Product/Process Change Notification No: PPS1105130C32

Subject: Diode TO-247 package change from 3-lead with dambar to true 2-lead with 100% Sn plate lead finish

From TO-247 3-lead with dambar

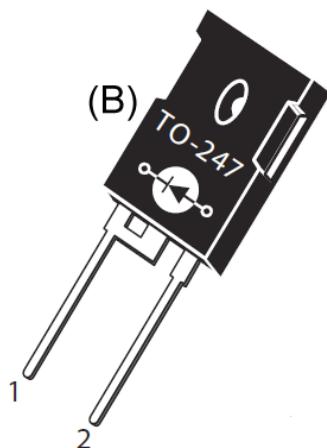
Description of Change: Microsemi power discrete, single diodes that are currently assembled in TO-247 (B pack) 3-lead packages with dambar will be changing to TO-247 (B pack) true 2-lead packages without dambar and with 100% Sn plate lead finish.

Reason for Change: Customer requests and increased high voltage clearance between leads.

To TO-247 true 2-lead

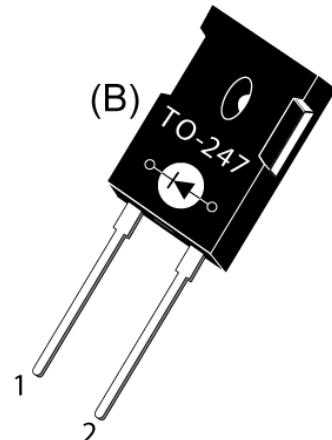
The lead frame can be identified visually as having either 3 leads with dambar or 2 leads without dambar.
